Rezoning Transportation Analysis

Petition Number: 2025-131

General Location Identifier: 10503131

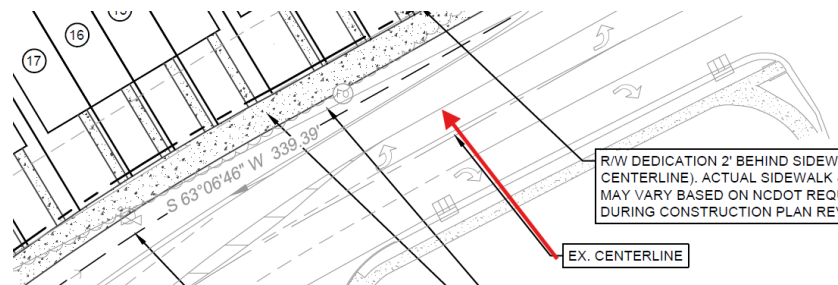
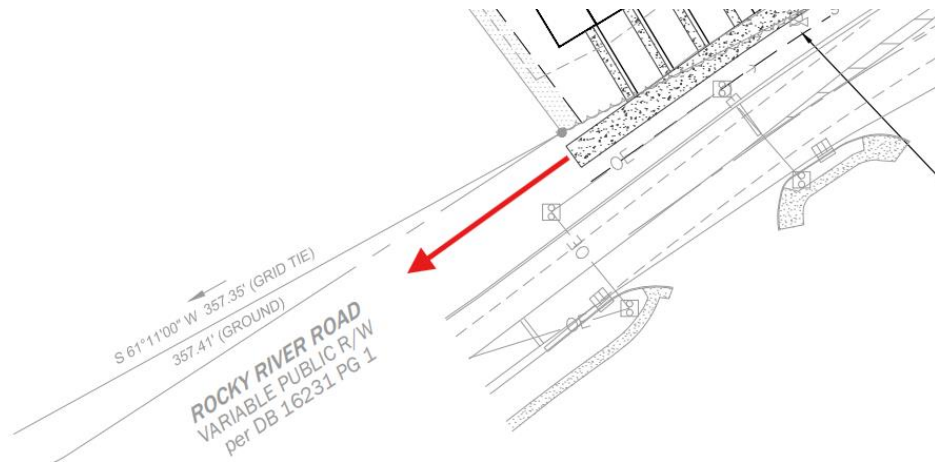
- a. **Rocky River Road:** Future back of curb and gutter is to be located 30 feet from road centerline and must be shown in the future location according to UDO Article 32.7 and Charlotte Streets Map.

Label and dimension the existing and future back of curb and gutter from the centerline for each road on the site plan.

CLARIFYING COMMENT 2-19-26: Revise callout/leader of "EX. CENTERLINE" to show existing striped center dividing line and show 2 westbound through-lanes along project frontage.

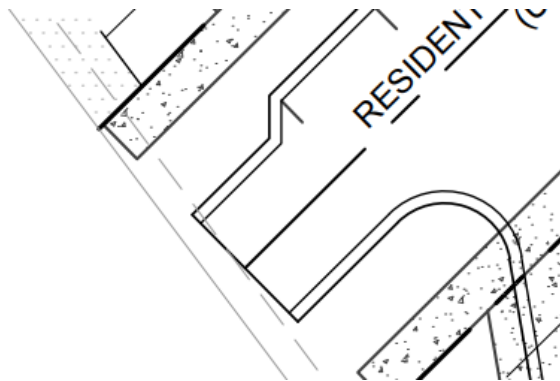
7. Revise site plan and conditional notes to commit to providing internal public road as Local Residential Wide Street with 8' planting strip and 8' sidewalk. Label and dimension the future back of curb and gutter from the centerline of the proposed road.

CLARIFYING COMMENT 2-19-26: Label and dimension the future back of curb and gutter from the centerline of the road on the site plan.

8. **OUTSTANDING COMMENT FROM 1-22-26:** Revise site plan and conditional note(s) to clarify how the proposed internal public road is to be terminated, whether a stub for future extension or a cul de sac for permanent dead end. Coordinate with subdivision to verify requirement.

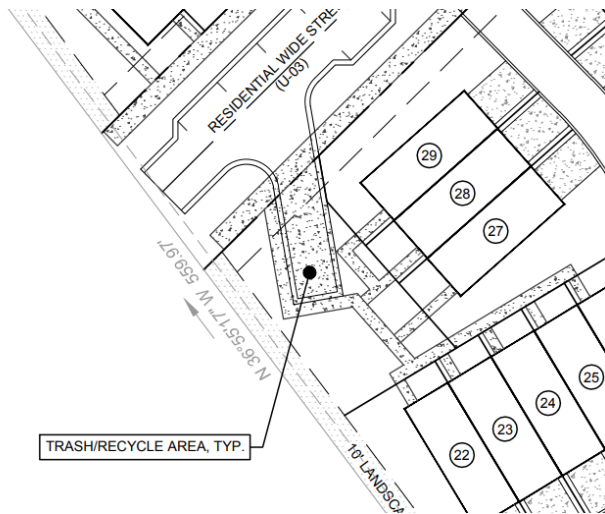
10. **OUTSTANDING COMMENT FROM 1-22-26:** Revise site plan and conditional note(s) to show that on-street parking must meet City standards, and ADA/PROWAG guidelines. Show proper spacing from driveways and curb ramps etc...One of the on street parking spaces are to be designed as an ADA stall.
